Aesthetics Analysis and Orderly Development Review

Northland Solar Project

PUC Case Number 25-2346-PET

Vermont Department of Public Service

Figure 1.1-2. Project Site and Layout

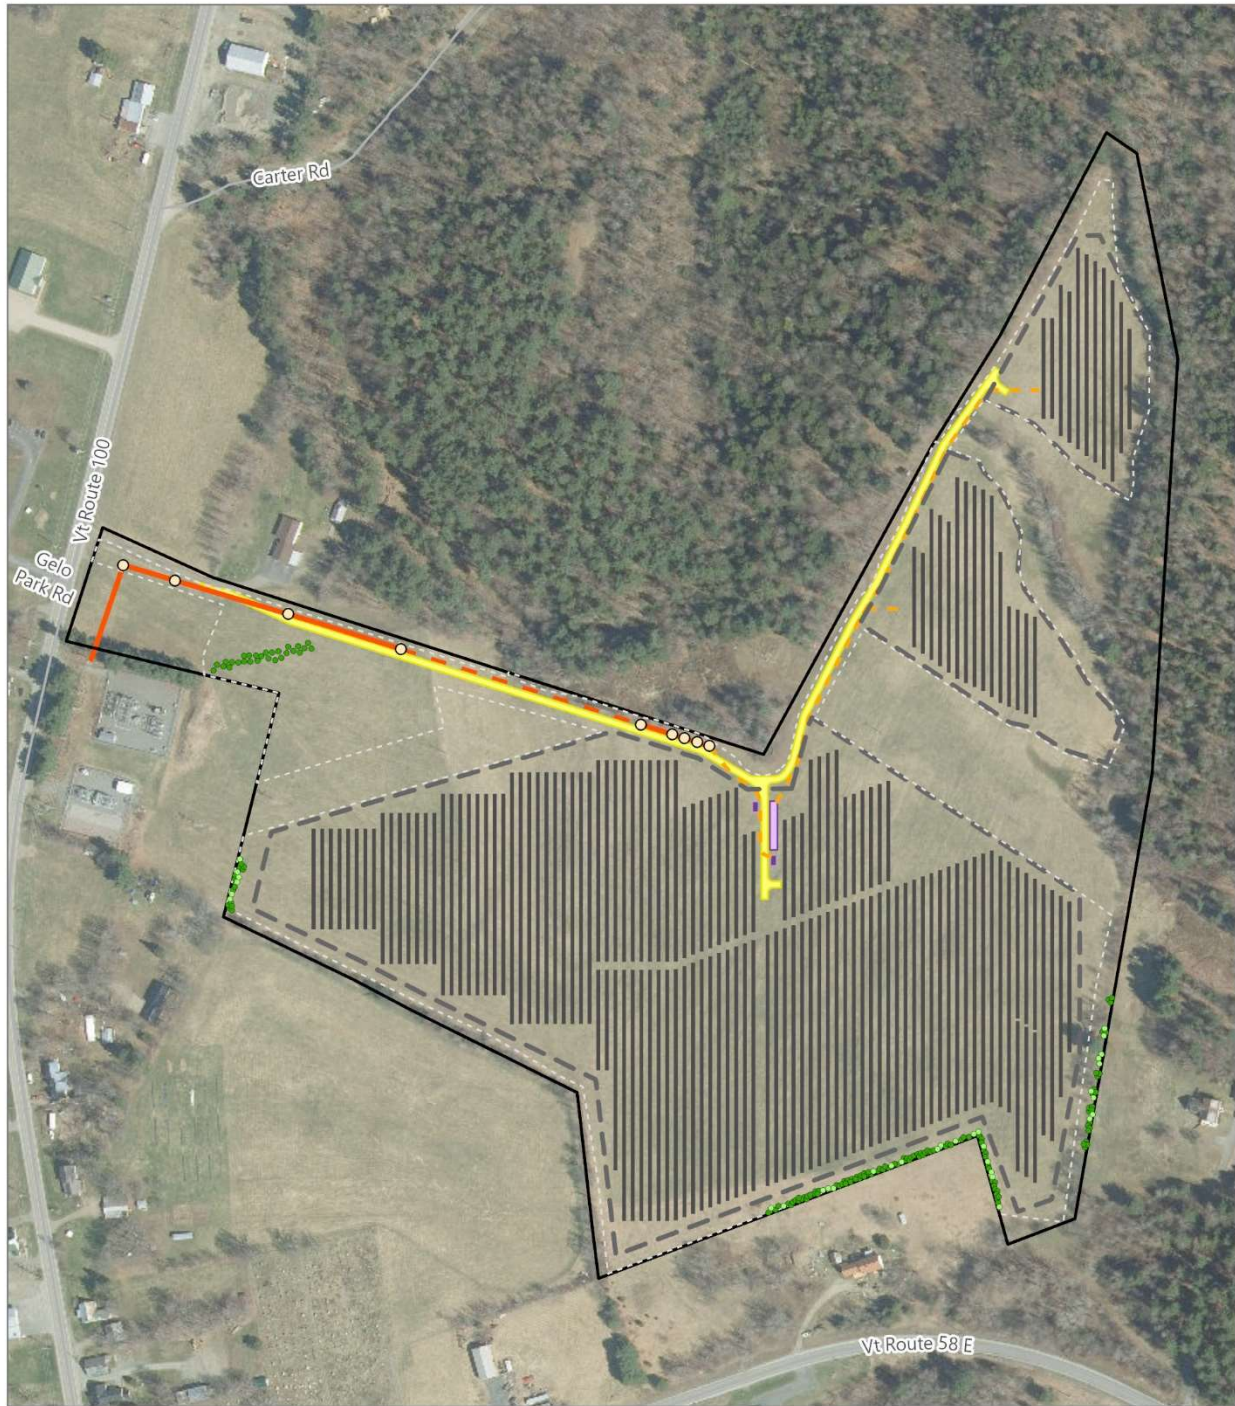
The gen-tie line structures, which have a maximum height of 45 feet above ground level, are fairly low in profile as currently proposed and likely have specific engineering requirements that limit options to further reduce their height such that visual impacts from near the Project entrance along State Route 100 could be

appreciably reduced. However, an alternative route where the gen-tie structures are set back further from State Route 100 could reduce visual impacts associated with this Project component from this area. Another option to mitigate visual impacts associated with the gen-tie line is undergrounding.

As illustrated in the photosimulation from Viewpoint 18, open views of the PV arrays are available during leaf off conditions from the Mountain View Cemetery. It is EDR's opinion that evergreen trees along the perimeter fence line or supplemental plantings in the hedgerow would effectively soften views of the Project in views and provide some benefit in views from the cemetery once established, but no plantings are currently proposed. If there are environmental or design constraints that limit the ability to propose mitigation plants in this area, they are not described in the application. Therefore, it is EDR opinion that the Petitioner has not taken generally available mitigation measures in terms of mitigation plantings.
